**SAN BRUNO RECREATION AND
AQUATIC CENTER PROJECT
RESPONSE TO COMMENTS DOCUMENT**

STATE CLEARINGHOUSE NO. 2019080096

May 2020

City of San Bruno
Community and Economic Development Department
567 El Camino Real
San Bruno, California 94066

RTC FIGURE 2-1

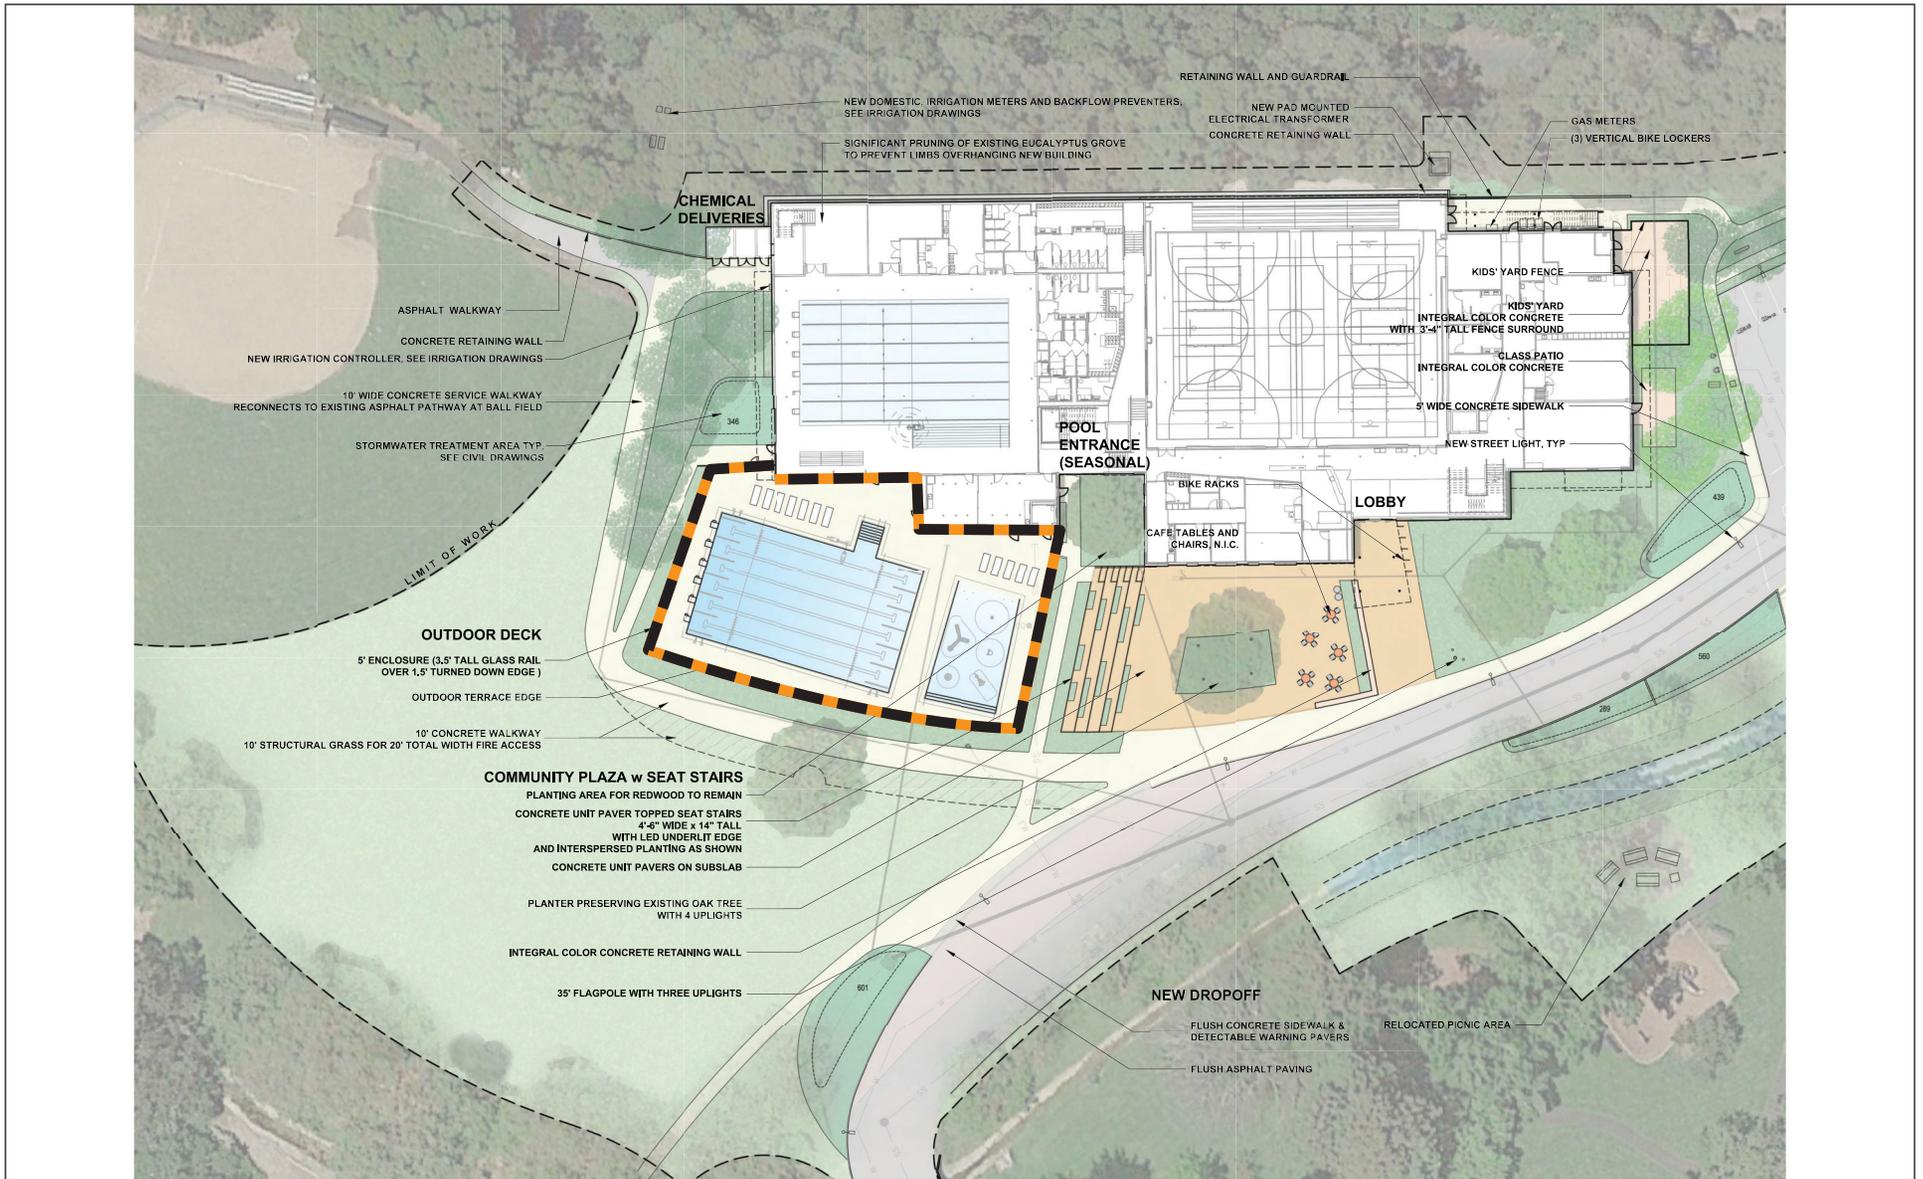
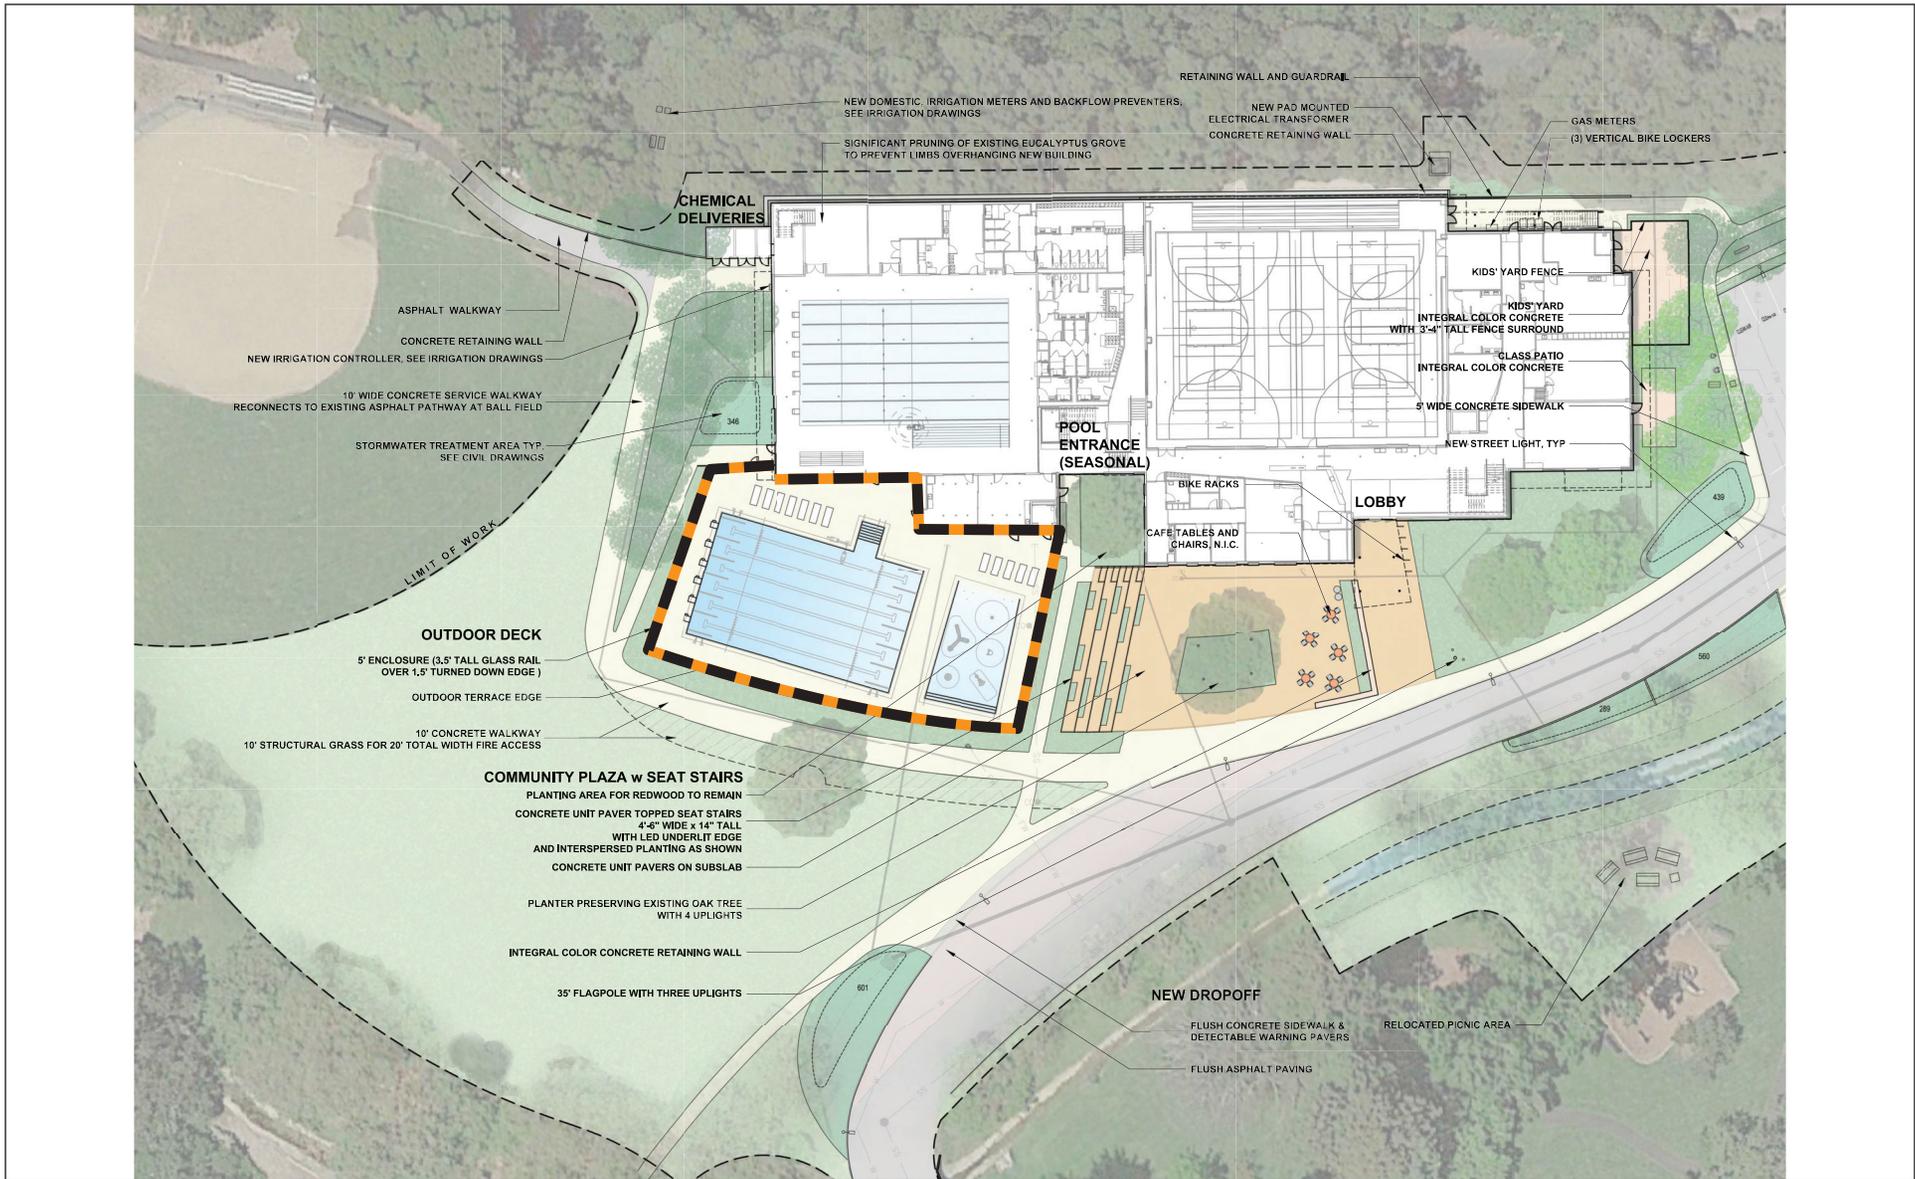
1. The total square footage of the proposed San Bruno Recreation and Aquatic Center (SBRAC) building would be increased by approximately 2,360 square feet, to a total of 49,360 square feet;
2. The portion of the reconfigured El Zanjón Creek located within the project site would be returned to a more natural state rather than rechannelized with a concrete base; and
3. The size and location of proposed storm drainage infrastructure improvements would be modified.

With implementation of the Revised Project, the proposed SBRAC building would total approximately 49,360 square feet in size, for an increase of 2,360 square feet (5 percent) compared to the project evaluated in the Draft EIR and 19,230 square feet compared to existing conditions. The increase in total gross building square footage is attributed to refinements in the second floor design including the expansion of the proposed fitness center by approximately 1,020 square feet and the inclusion of additional flex space. No increase in the proposed programming or use of the facility is anticipated beyond what was considered in the Draft EIR. RTC Figures 2-1 through 2-5 reflect the development program for the SBRAC facility as proposed by the Revised Project, including the Conceptual Site Plan (Draft EIR Figure 3-6); Conceptual SBRAC Facility Plan (Draft EIR Figure 3-7); Conceptual First Floor Plan (Draft EIR Figure 3-8); Conceptual Second Floor Plan (Draft EIR Figure 3-9); and Conceptual Building Elevations (Draft EIR Figure 3-10).

Figure 3-6 on page 3-11 of the Draft EIR is revised as shown in RTC Figure 2-1 in Chapter 2.0 of this RTC Document and on the following pages.

REVISED FIGURE 3-12

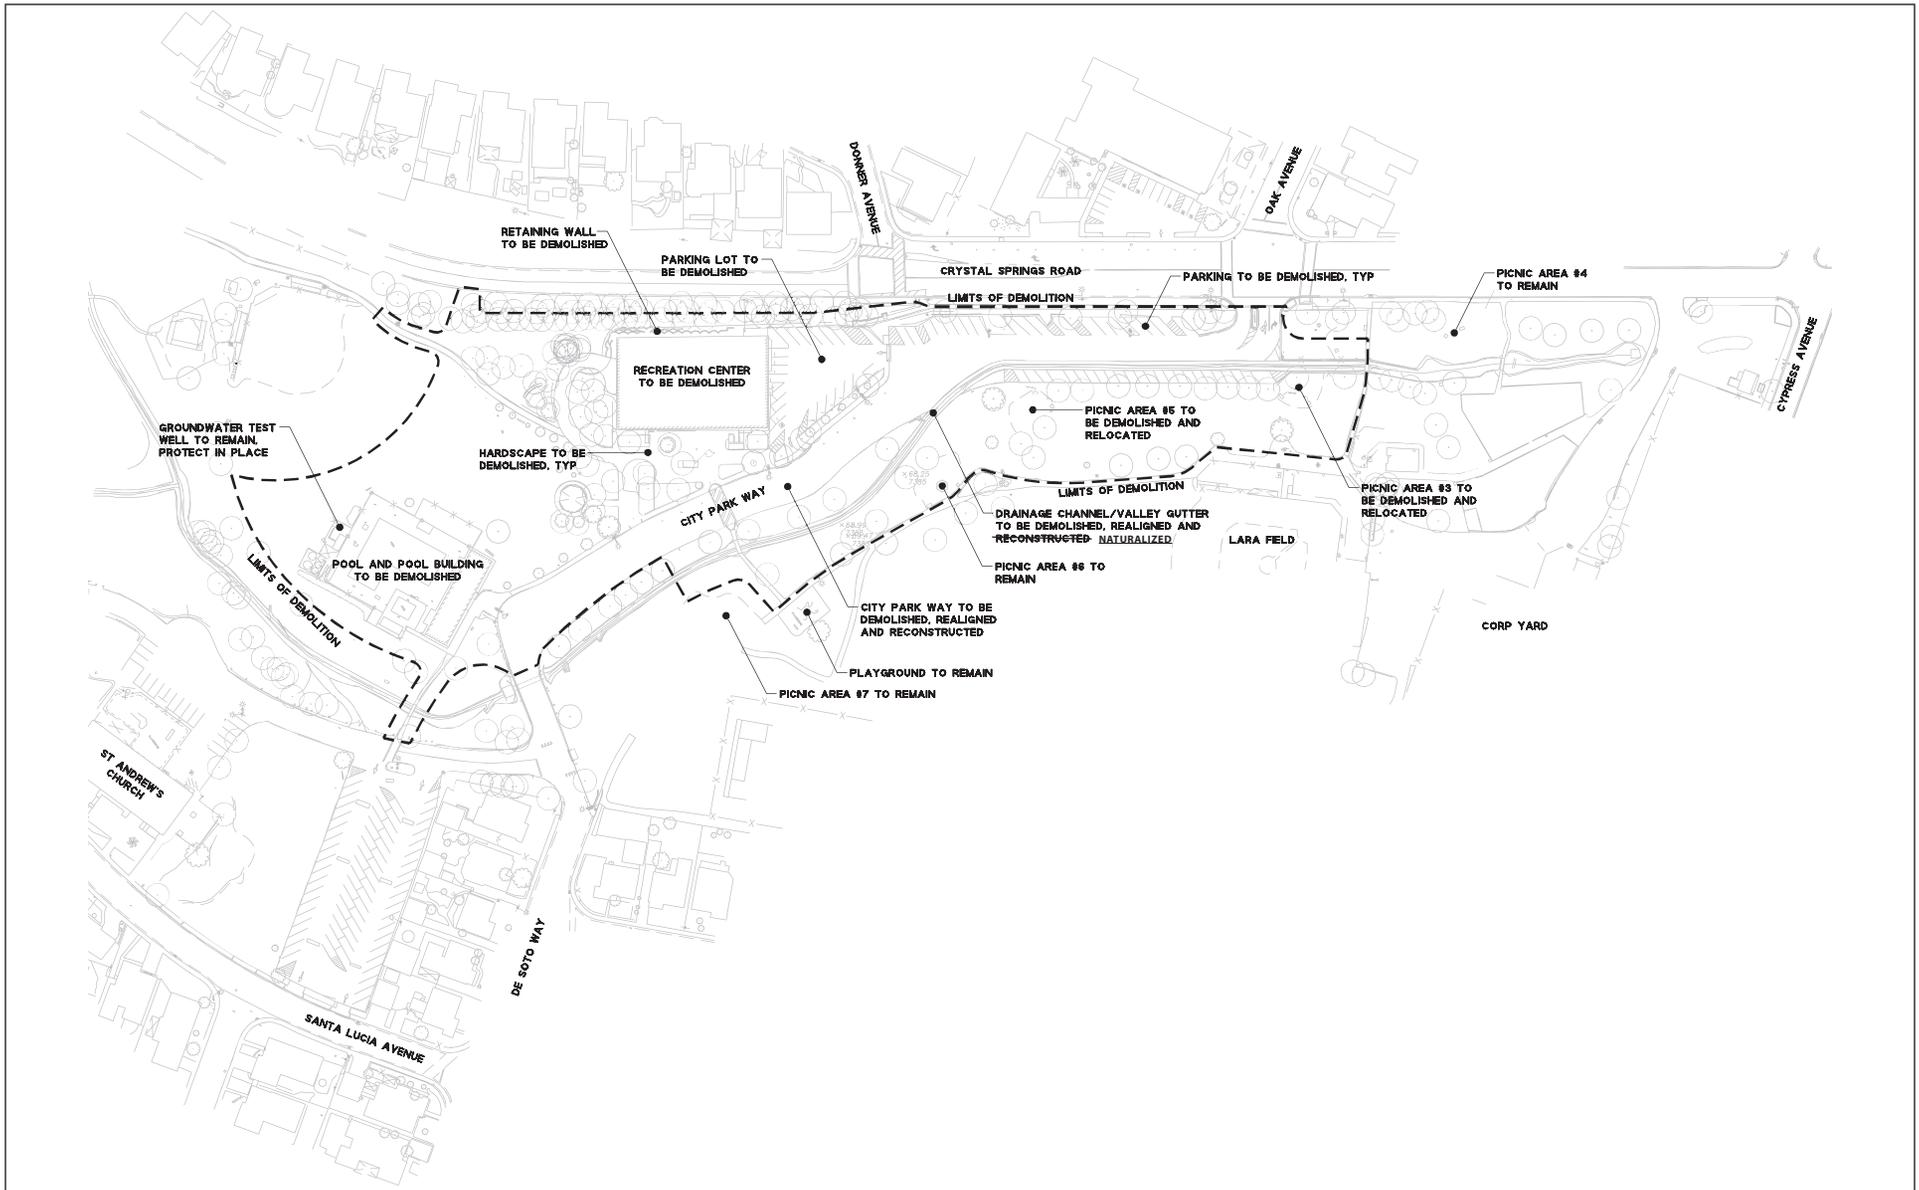
With implementation of the Revised Project, similar to the project evaluated in the Draft EIR, the proposed storm drainage infrastructure would convey on-site stormwater runoff in a new 6- to 24-inch storm drain system, which would discharge to El Zanjon Creek via four storm drain outfalls. From there, stormwater would drain northeasterly into an existing concrete lined drainage channel before discharging to an underground storm drain box culvert at the eastern edge of the project site. Nine (rather than five, as identified in the Draft EIR) stormwater treatment areas, consisting of lined bioretention areas and pervious pavement areas, are proposed with the Revised Project. One of the stormwater treatment areas would be located southwest of the proposed SBRAC building, one would be located between the east corner of the proposed SBRAC building and the south corner of the parking lot, one would be located adjacent to the City Park Way dropoff area, and five would be located between City Park Way and the realigned El Zanjon Creek. Pervious pavement would be located at the southeastern row of parking stalls within the proposed parking lot to the north of the SBRAC building. The stormwater treatment areas would be vegetated and allow for up to 12 inches of ponding with a layer of bioretention soil and a layer of permeable rock and subdrain. Overflow would be discharged from the stormwater treatment areas to the onsite storm drain system which would connect to outfalls in the realigned, earthen El Zanjon Creek channel.

RTC Figure 2-6 reflects the storm drainage infrastructure improvements as proposed by the Revised Project. This figure replaces Figure 3-12 in the Draft EIR.

The proposed storm drainage infrastructure would ~~drain towards the concrete-lined drainage channel within the site~~ convey on-site stormwater runoff in a new 6- to 24- to 12-inch storm drain system, which would discharge to El Zanjon Creek via four storm drain outfalls. From there, stormwater would drain northeasterly into an existing concrete lined drainage channel before discharging into an ~~from the drainage channel to the east, discharging into an existing~~ underground storm drain box culvert at the eastern edge of the project site. As shown in Figure 3-12, five ~~nine~~ stormwater treatment areas, consisting of lined bioretention areas and pervious pavement areas, are proposed on the project site. One of the stormwater treatment areas would be located southwest of the proposed SBRAC building, ~~one would be located between the east corner of the proposed SBRAC building and the south corner of the parking lot, one would be located adjacent to the City Park Way dropoff area,~~ and three ~~five~~ would be located between City Park Way and north of the realigned El Zanjon Creek. Pervious pavement would be located at the southeastern row of parking stalls within the proposed parking lot to the north of the SBRAC building. The stormwater treatment areas would be vegetated and allow for up to 12 inches of ponding with a layer of bioretention soil and a layer of permeable rock. Overflow would be discharged from the stormwater treatment areas to the onsite storm drain system which would connect to outfalls in the realigned, ~~concrete-lined~~ El Zanjon Creek channel.

Figure 3-12 on page 3-16 of the Draft EIR is revised as shown in RTC Figure 2-6 in Chapter 2.0 of this RTC Document and on the following pages.
